Work Order ID 105306

Item ID: D3303-043 Accept *N900040100* Setup Start *NS1*
 Revision ID: Stop *NS2*
 Item Name: Bracket Assembly
 Start Date: 8/01/13 Start Qty: 1.00 *1* Cust Item ID:
 Required Date: 8/01/13 Req'd Qty: 1.00 *1* Customer:
 Reference:

DESIGN <i>PH</i>	DRAWN BY <i>B</i>	DART AEROSPACE LTD HAWKESBURY, ONTARIO, CANADA	
CHECKED <i>PH</i>	APPROVED <i>B</i>	DRAWING NO. D3303	REV. B SHEET 1 OF 4
DATE 06.08.17		TITLE HEAD REST	SCALE 1:3
REV	DATE	DESCRIPTION	
A	04.08.18	NEW ISSUE	
B	06.08.17	UPDATED FLAT PATTERN TO FORM PART IN ONE OPERATION USING OFFSET DIE

DRAWING NO. D3303	TITLE HEAD REST	REV. B	DART AEROSPACE LTD ENGINEERING ORDER		D.E.O. NO. D3303-B-1	SHEET NO. SHEET 1 OF 1	SCALE NTS
DRAWN AJS	CHECKED <i>L</i>	MFG. APPR. <i>MA</i>	APPROVED <i>MA</i>	DE APPR. <i>MA</i>			
DATE 08.10.15	DATE <i>08.10.15</i>	DATE <i>08/10/16</i>	DATE <i>08/10/16</i>	DATE <i>08/10/16</i>

D3303-041 HEAD REST

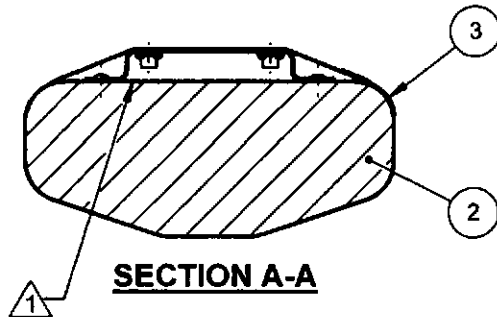
SHEET 1 ADD 1300L ADHESIVE BY 3M TO NOTE 1 AS FOLLOWS:

WAS:

- 1) BOND D3305-1 FOAM TO D3303-043 BRACKET ASSEMBLY USING 3M 1300 ADHESIVE (0.002" TO 0.010" THICK) IN ACCORDANCE WITH MANUFACTURER'S INSTRUCTIONS

IS:

- 1) BOND D3305-1 FOAM TO D3303-043 BRACKET ASSEMBLY USING 3M 1300 OR 1300L ADHESIVE (0.002" TO 0.010" THICK) IN ACCORDANCE WITH MANUFACTURER'S INSTRUCTIONS
